#### Federal Motor Vehicle Safety Standards; Electric-Powered Vehicles: Electrolyte Spillage and Electrical Shock Protection

**ACTION:** Notice of proposed rulemaking (NPRM).

2. Amend § 571.305 by revising S1, S2, S3, S4, S5.2, S5.3, S6.2, S7, S7.1, S7.2, S7.4, S7.6, S7.6.1, S7.6.2, S7.6.3, S7.6.4, S7.6.5, S7.6.6, and S7.6.7 to read as follows:

Figure 1. S7.6.6 Measurement of High Voltage Source for Vb Voltage

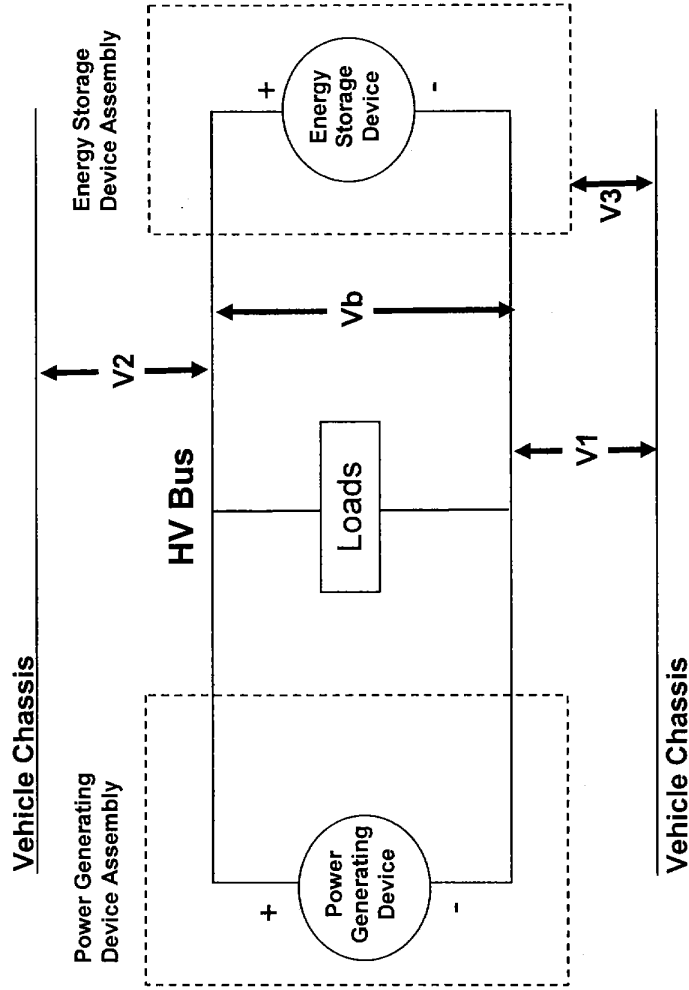
S7.6.3 The voltage(s) is/are measured as shown in Figure 1 and the high-voltage source voltage(s) (Vb) is/are recorded. Before any vehicle impact test, Vb is equal to or greater than the nominal operating voltage as specified by the vehicle manufacturer.

3. Further amend § 571.305 by revising Figures 1, 2, 3, 4, and 5 following S7.6.7 to read as follows:

Figure 2. S7.6.4 Measurement for V1 Voltage between the Negative Side of the High Voltage Source and the Vehicle Chassis

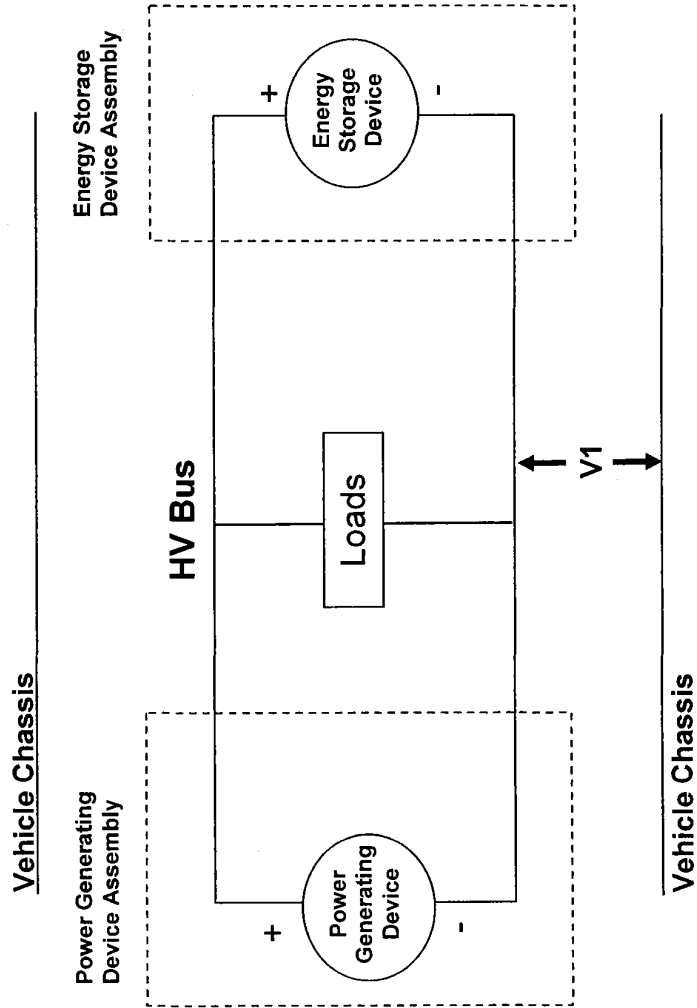
S7.6.4 The voltage(s) is/are measured as shown in Figure 2, and the voltage(s) (V1) between the negative side of the high-voltage source and the vehicle chassis is/are recorded.

Figure 3. S7.6.5 Measurement for V2 Voltage between the Positive Side of the High Voltage Source and the Vehicle Chassis

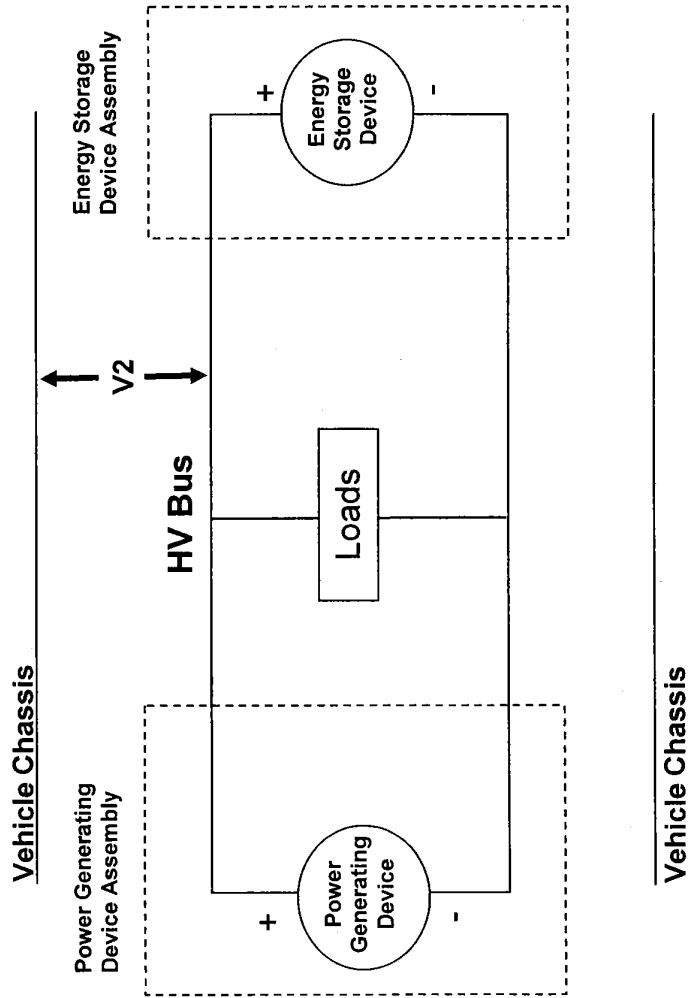
S7.6.5 The voltage(s) is/are measured as shown in Figure 3, and the voltage(s) (V2) between the positive side of the high-voltage source and the vehicle chassis is/are recorded.

Figure 4. S7.6.6 Measurement for V1' Voltage across Resistor between Negative Side of the High Voltage Source and Vehicle Chassis

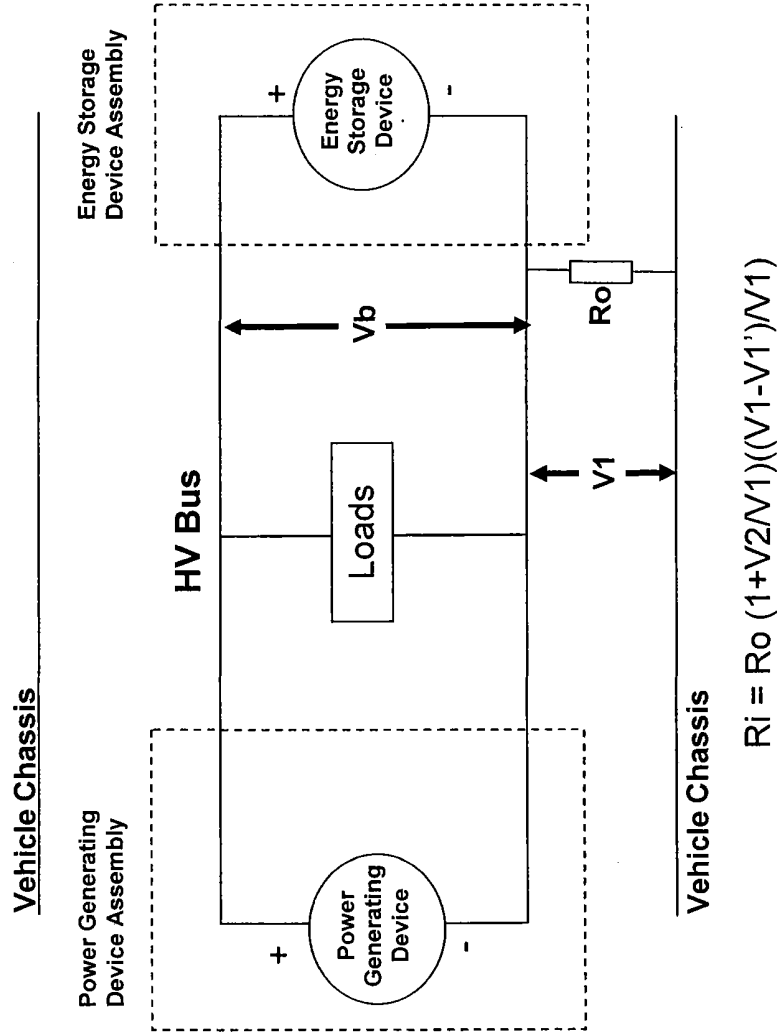
S7.6.6 If V1 is greater than or equal to V2, insert a known resistance (Ro) between the negative side of the high-voltage source and the vehicle chassis. With the Ro installed, measure the voltage (V1') as shown in Figure 4 between the negative side of the high-voltage source and the vehicle chassis. Calculate the electrical isolation (Ri) according to the formula shown.

Figure 5. S7.6.7 Measurement for V2' Voltage across Resistor between Positive Side of the High Voltage Source and Vehicle Chassis

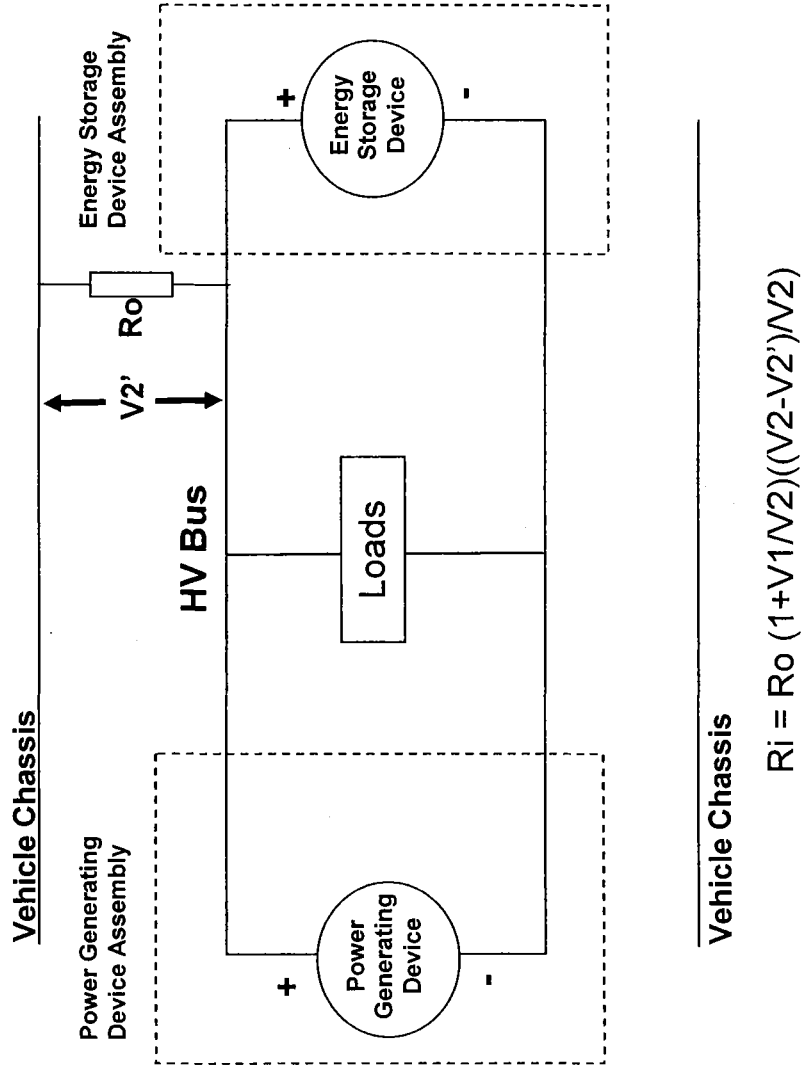
S7.6.7 If V2 is greater than V1, insert a known resistance (Ro) between the positive side of the high-voltage source and the vehicle chassis. With the Ro installed, measure the voltage and record the voltage (V2') between the positive side of the high-voltage source and the vehicle chassis as shown in Figure 5. Calculate the electrical isolation (Ri) according to the formula shown.
